PROPOSAL REQUEST (PR)

PROJECT NAME ERC Residential Program and PHP		ARCHITECT'S PROJECT NO. 132258.00
PR NO. 09		FILE CODE G1-Documents
DATE ISSUED 03 18 2014	CONTRACT FOR General Construction	CONTRACT DATED
ARCHITECT Boulder Associates, Inc. 1426 Pearl Street, Suite 300 Boulder, CO 80302	CONTRACTOR GH Phipps 5995 Greenwood Plaza Blvd. Suite 100 Greenwood Village, CO 80111	OWNER Eating Recovery Center 7351 E. Lowry Blvd Suite 200 Denver, CO 80230

This PR documents the changes marked-up / revised per the casework, fireplace, and teaching kitchen hood, and kitchen submittals.

17 CASEWORK TYPE "B26"
A7.4 1" = 1'-0"

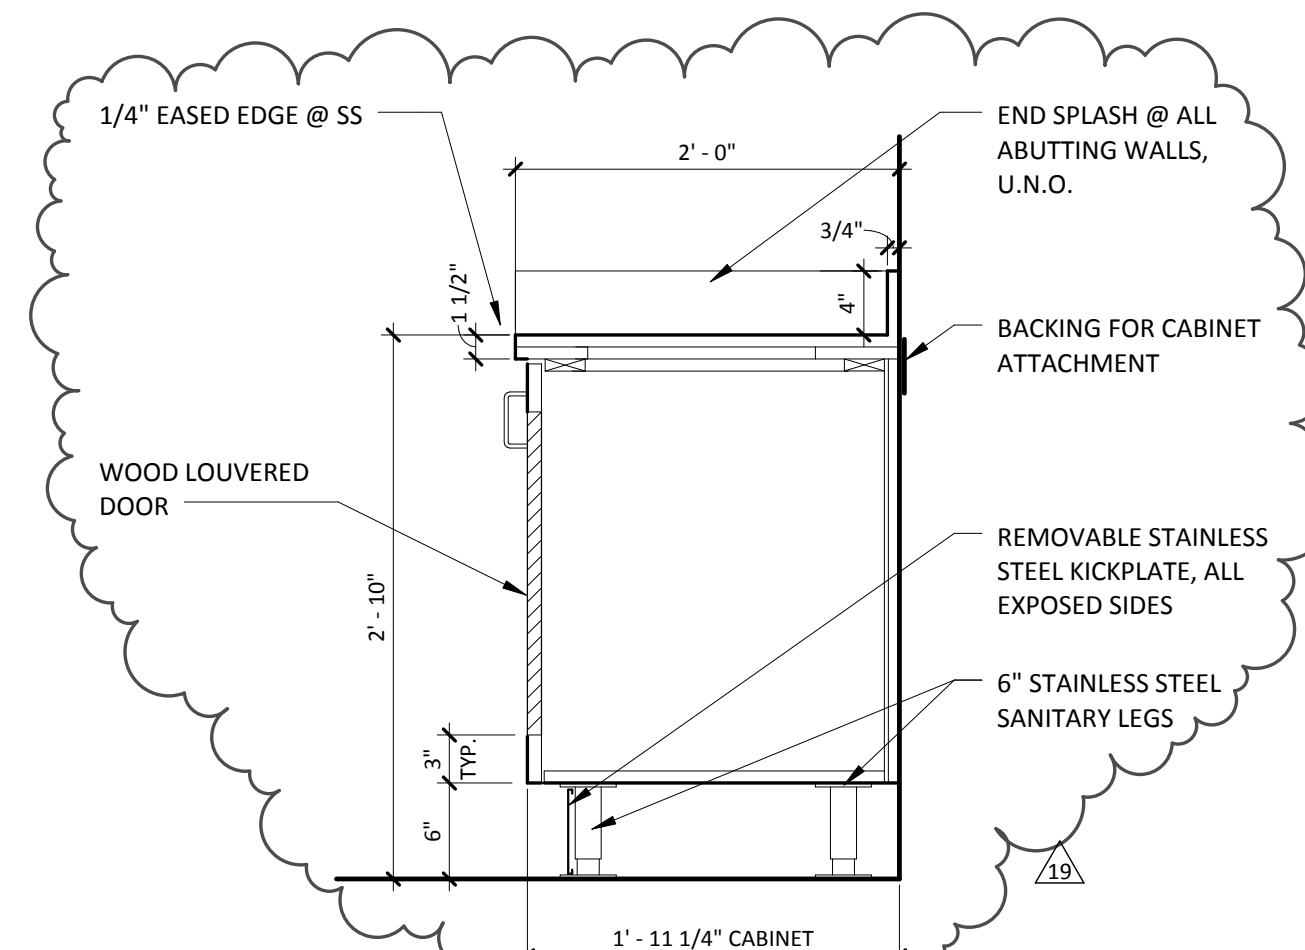
1. Added casework type "B26" to provide required food service legs as required by code in Dining 161. See 3/A6.2 and 17/A7.4
2. Added finished p-lam panel at East side counter in 161 and clarified dimensions. See 3/A6.2

18 CASEWORK TYPE "B27"
A7.4 1" = 1'-0"

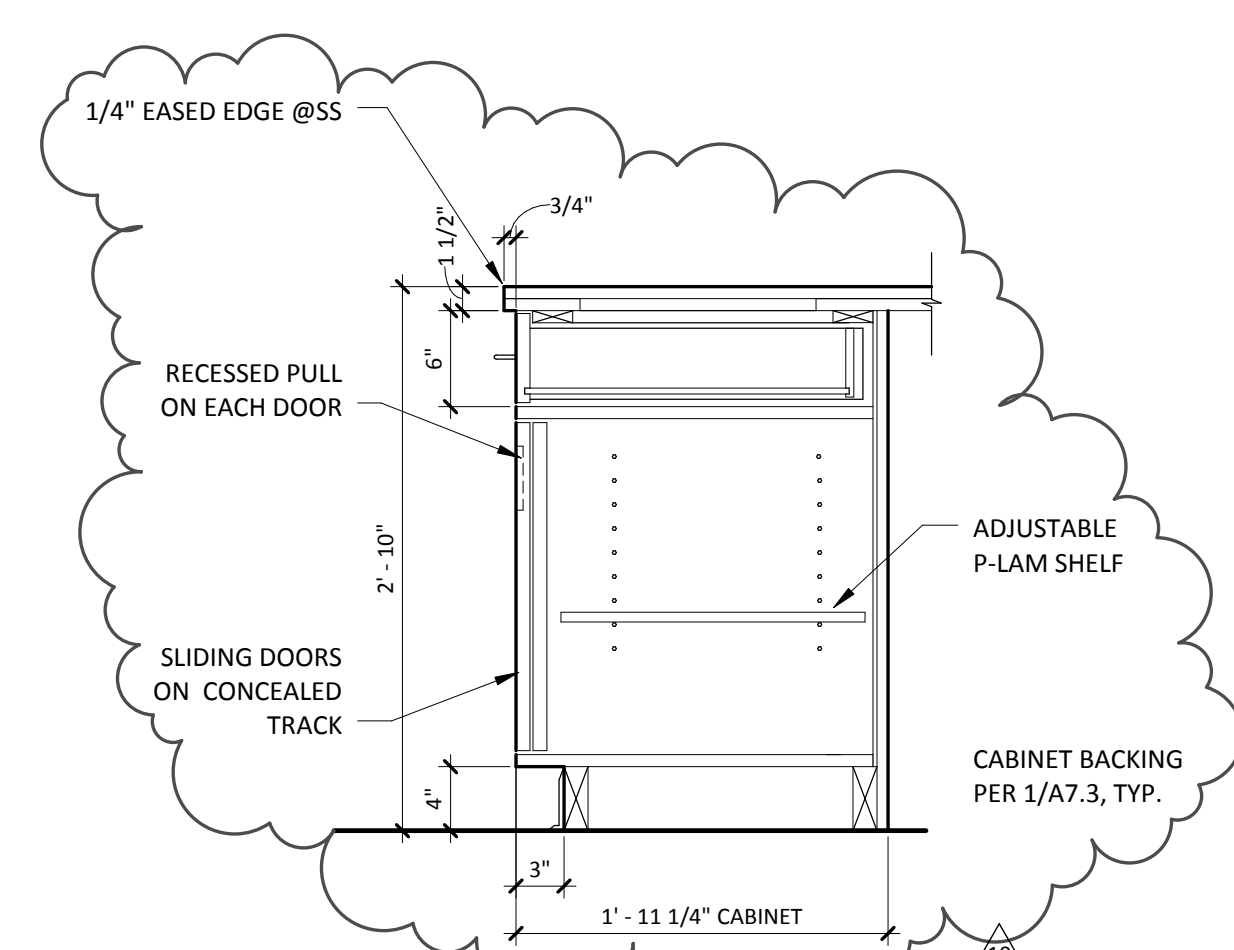
3. Added casework type "B27" to clarify with the sliding casework doors shown in elevations 6 & 9/A6.2 and 18/A7.4
4. Revised East elevation of Teaching Kitchen (10/A6.2) to provide required side approach door clearance and revised location of the Ansul system box to fit in cabinet (21"W x 24"H x 8" D)

3 OVERHEAD COILING DOOR @ HEADER

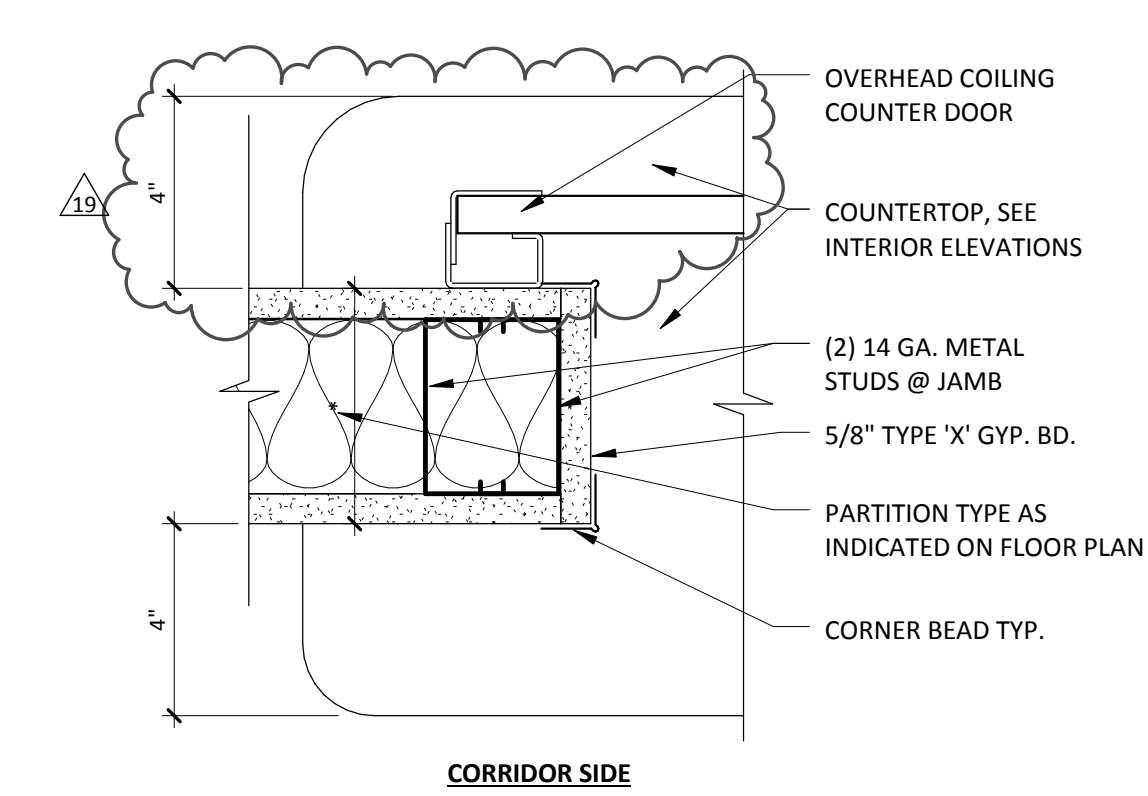
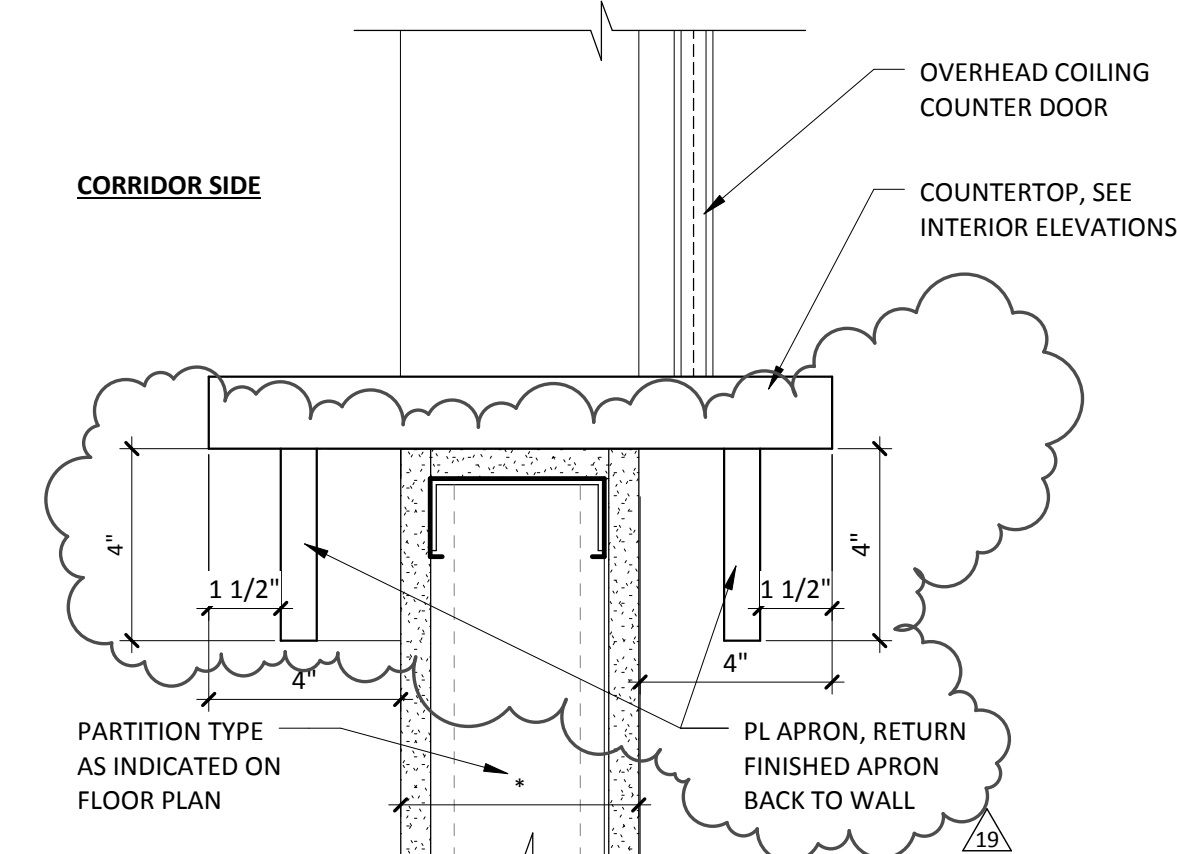
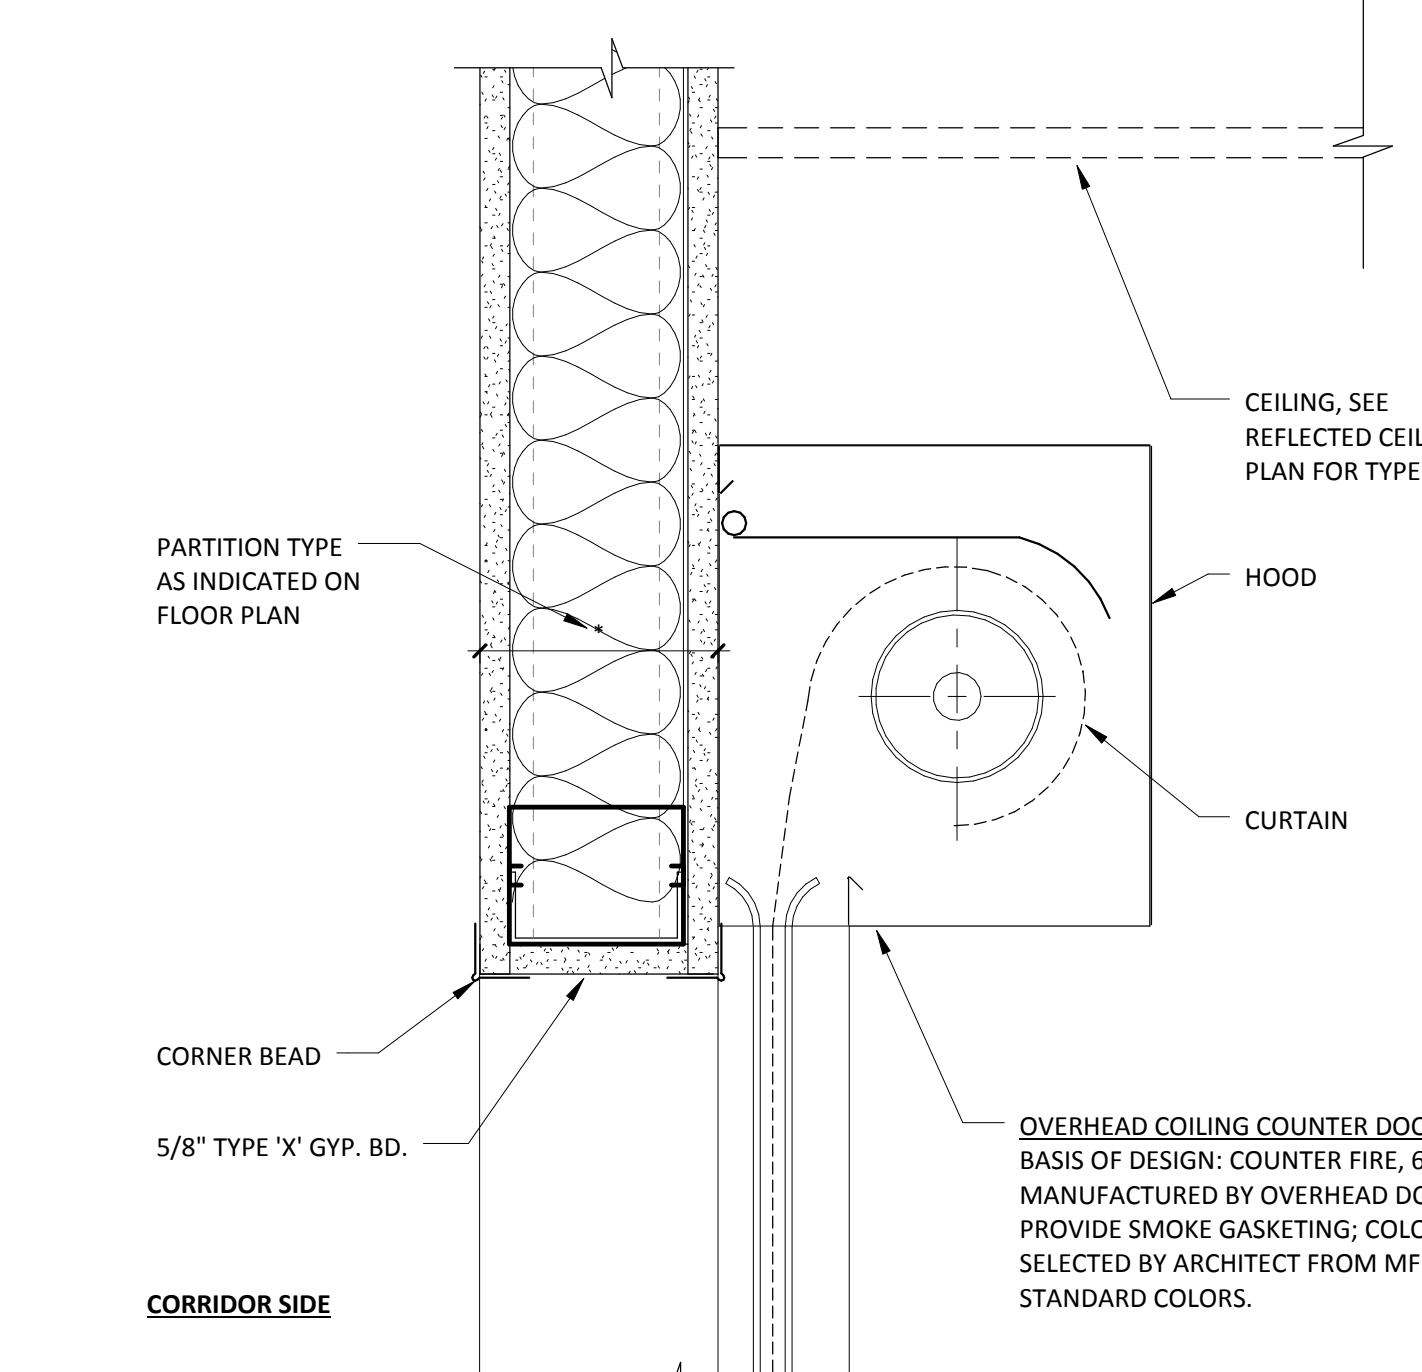
7. Modified counters at coiling counter doors in Meds Rooms 275 and 276 to be 4" deep in lieu of 24" on room side. See 1, 3, & 5/A6.4 and
8. Revised fireplace type and elevation in room 292, per returned fireplace submittal. See 12/A6.4.

A9.1B

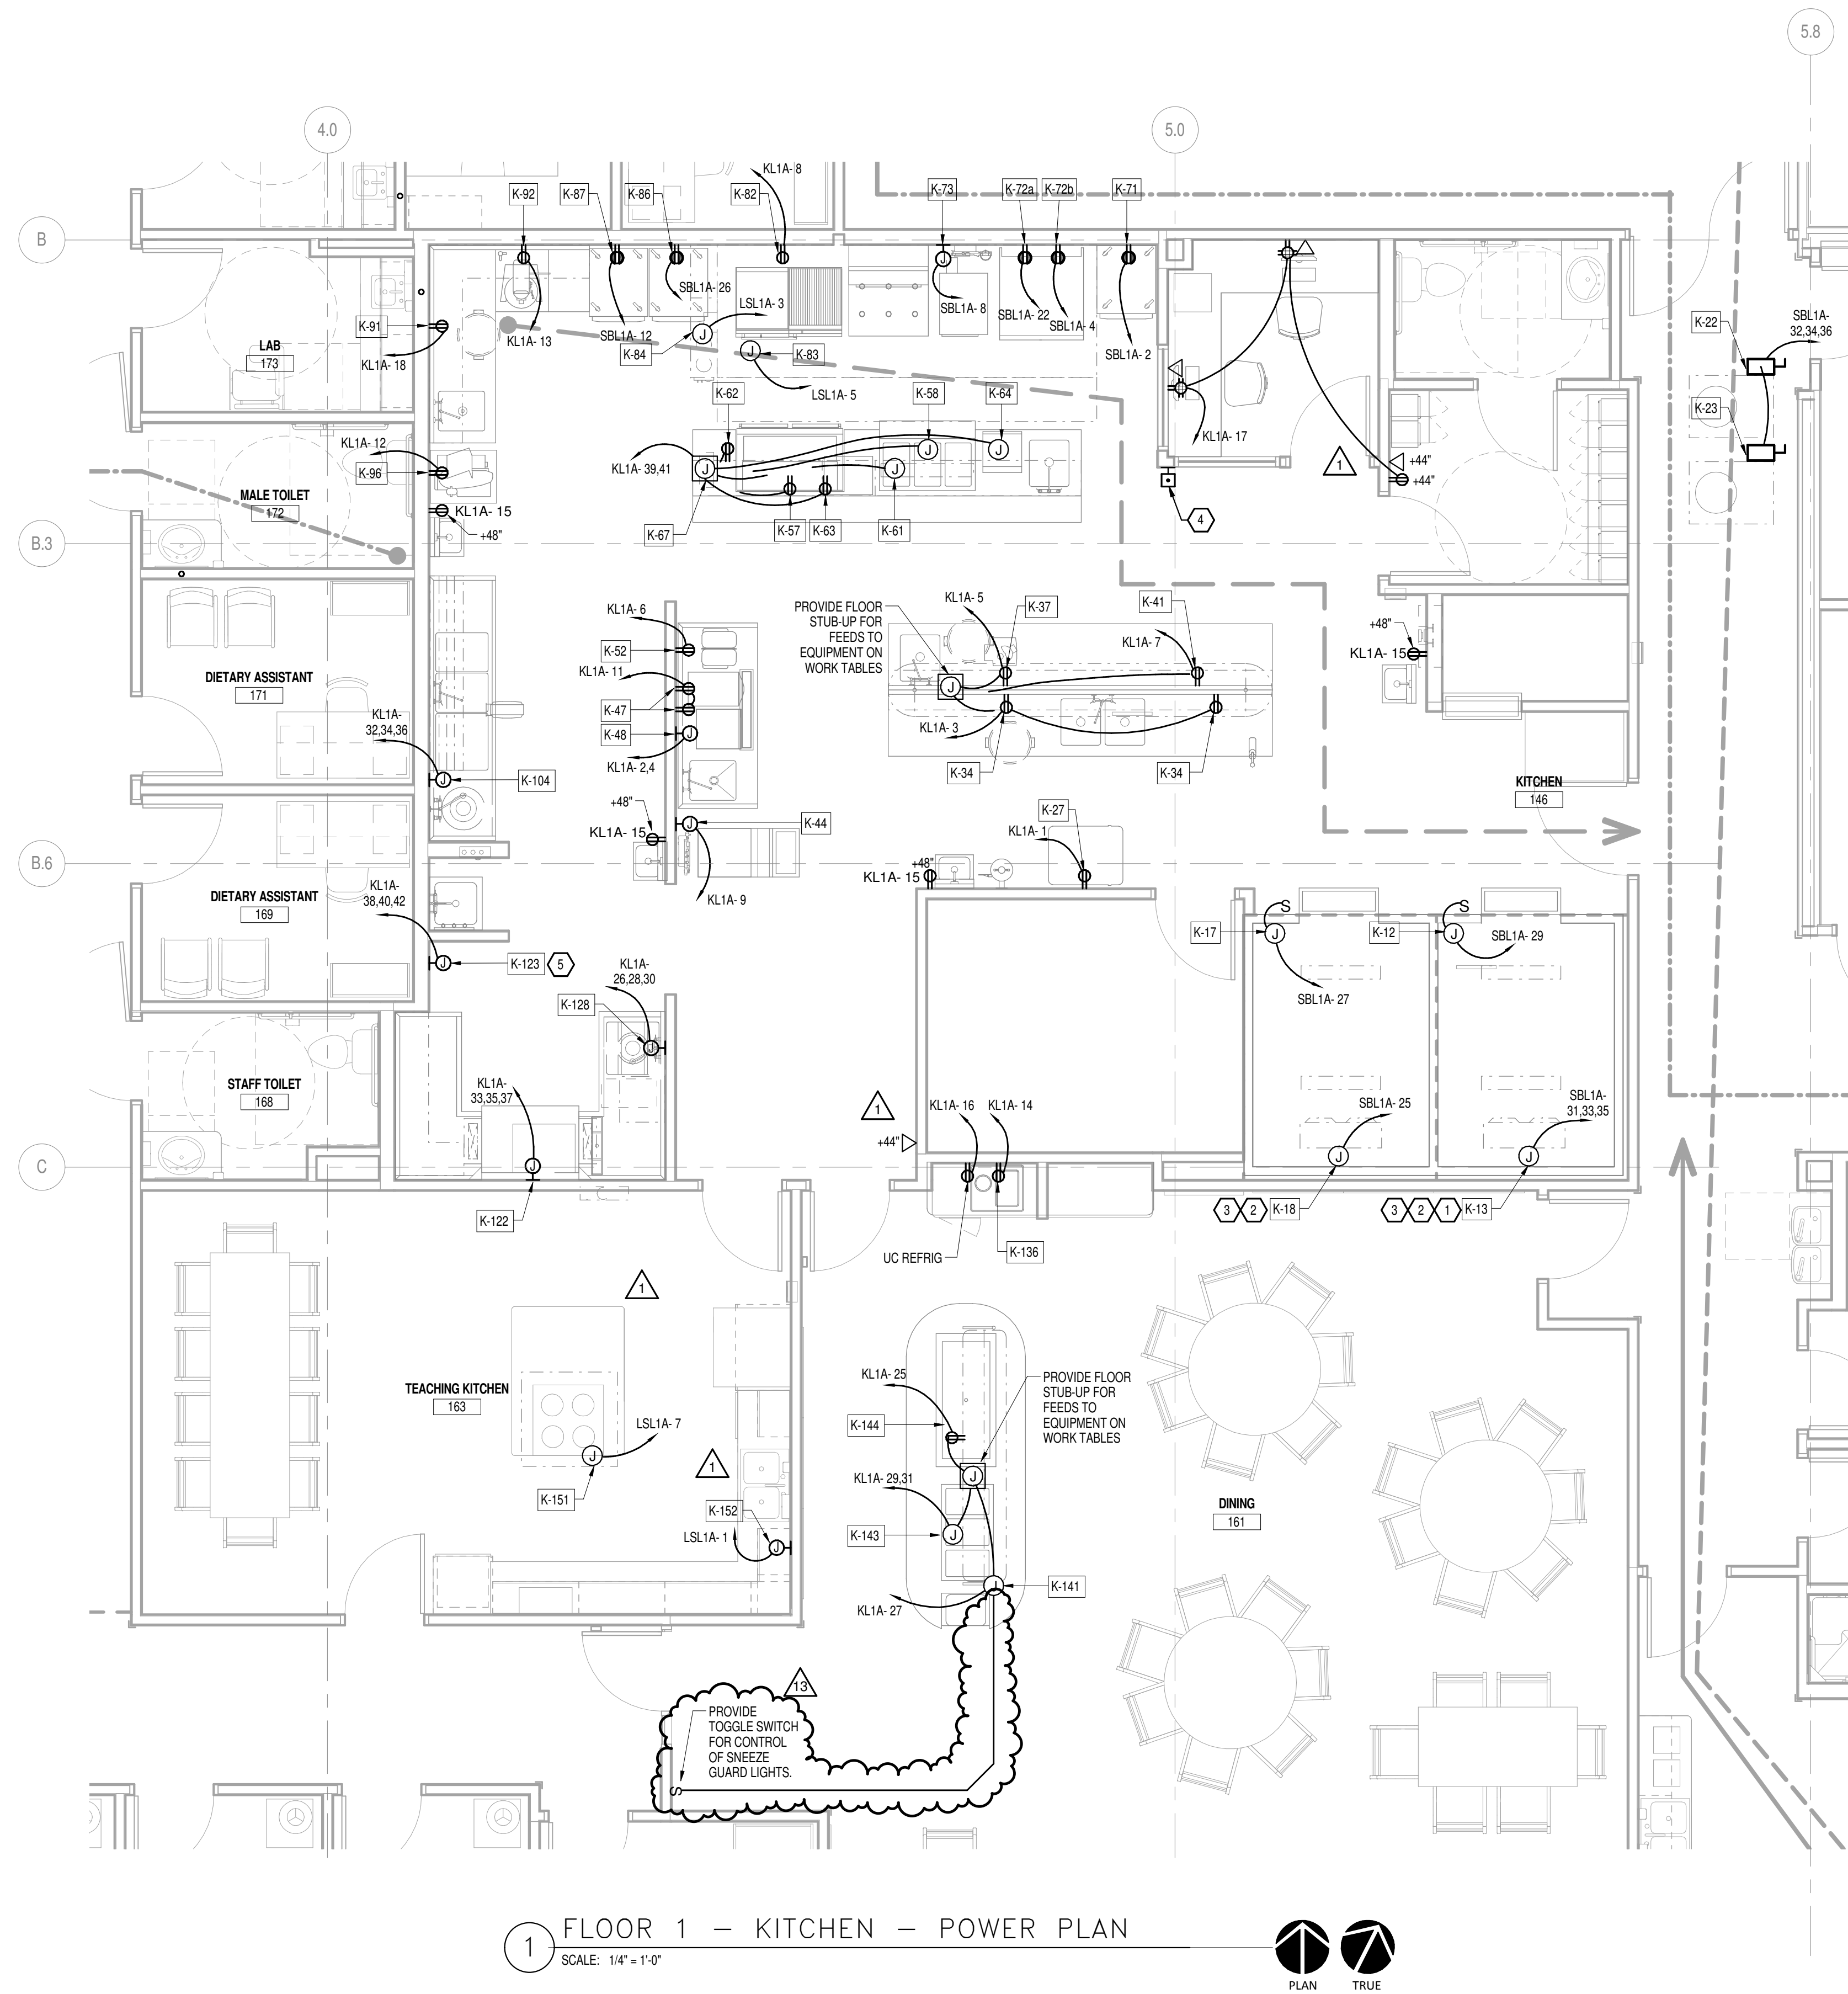
9. Revised height of island soffit in Teaching Kitchen 163 per comments in submittal to provide minimum bottom of hood dimension of 6'-8". See A9.1B.
10. Add switch for control of sneeze guard lights as shown on revised sheet E4.1.
